# SERVICE LETTER

No. 594

Subject: Inspection of Flap Track and Rudder Tip Rib Assemblies

Models Affected: PA-31 and PA-31-300 Navajo

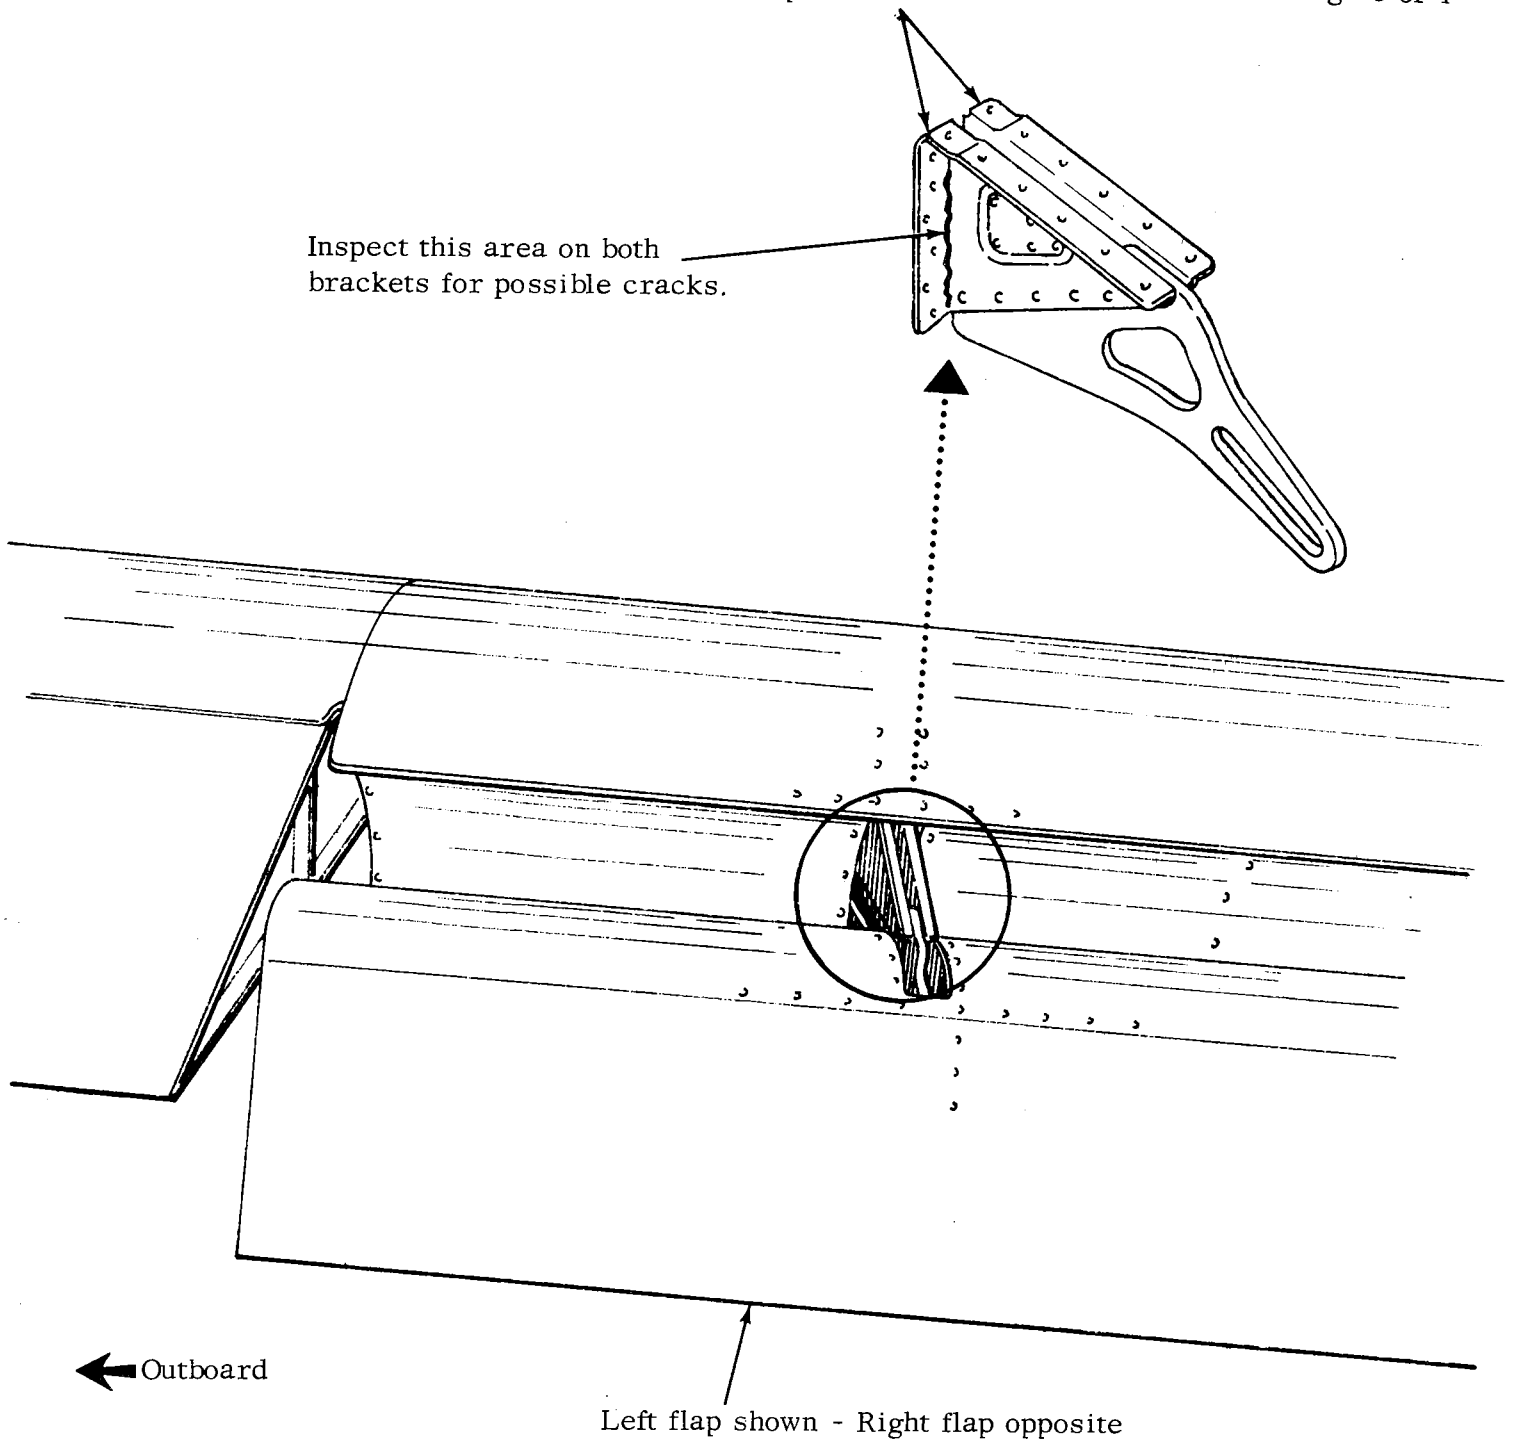
I. PA-31, Serial Nos. 31-1 to 31-172 incl.  
Product condition information indicates that the outboard flap track assemblies on the above referenced aircraft are susceptible to cracks appearing along the inside angle of the flap track bracket. A change was made in production to the flap track assembly effective on serial numbers 31-173 and up.

Inspect this area on both brackets for possible cracks.

1. Lower the flaps and inspect the outboard flap track brackets for possible cracks.
2. If cracks are found, replace with new reinforced Flap Track Assembly, P/N 43764-00 for left wing or P/N 43764-01 for right wing.

**SKETCH "B"**

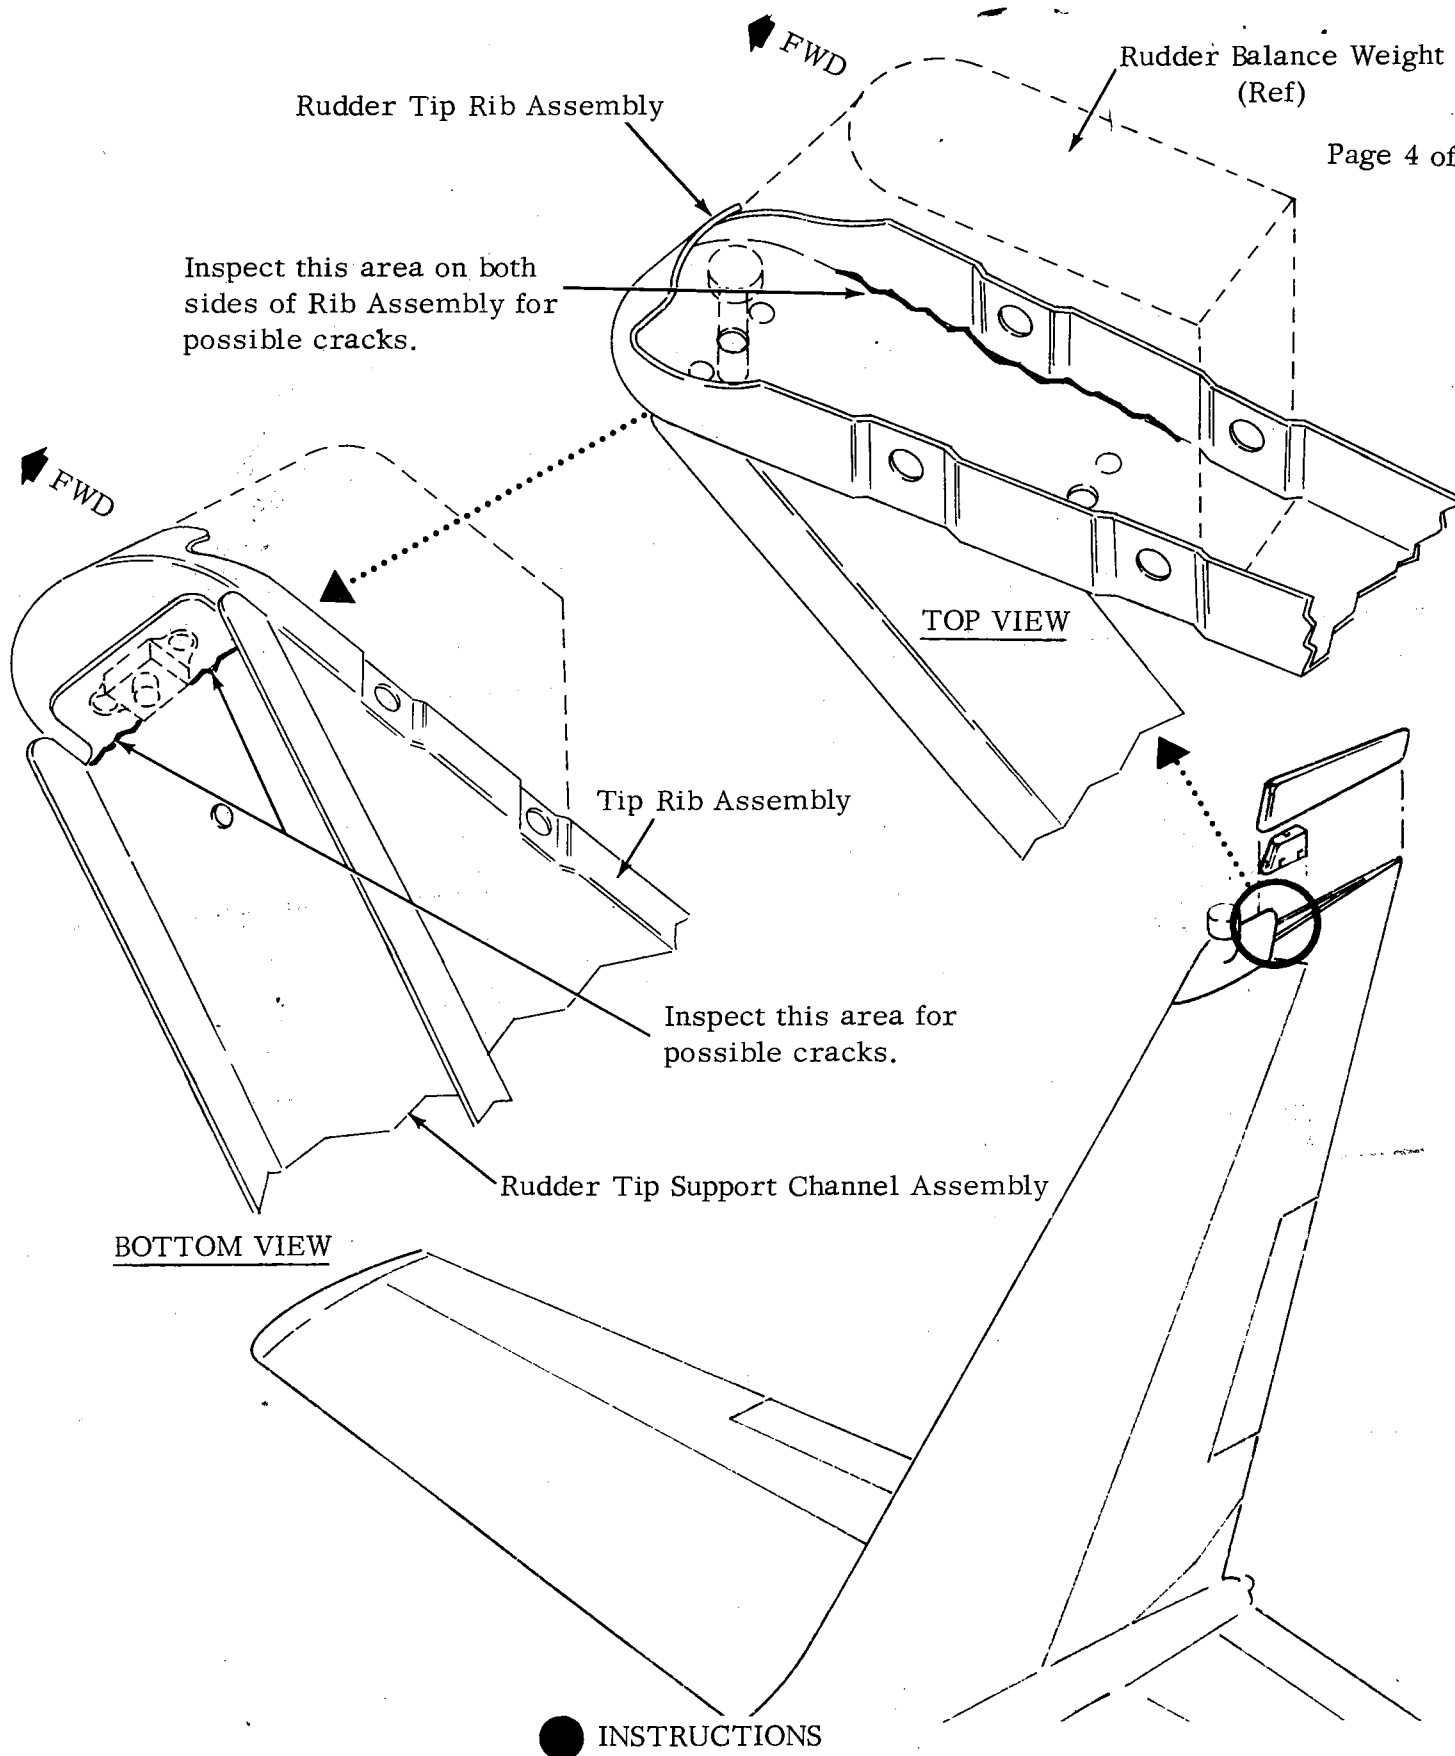
II. PA-31 and PA-31-300, Serial Nos. 31-1 to 31-460 incl.  
A recent product serviceability report described the appearance of cracks along the inside angle of the rudder tip rib (supporting the rudder balance weight) and the underside of the rudder tip support channel assembly. This Service Letter provides instructions to inspect this area for possible cracks. Attached sketch "B" contains inspection illustrations and instructions, with material replacement (if required) recommendations.

1. Remove rudder tip and balance weight from rudder and inspect rib for possible cracks.
2. If cracks are found, replace with new reinforced Rib Assembly, Part No. 40044-00.
3. If Rib Assembly must be replaced, also inspect underside of Rudder Tip Support Channel Assembly for possible cracks. If cracks are found, replace with new Channel Assembly, Part No. 40045-00
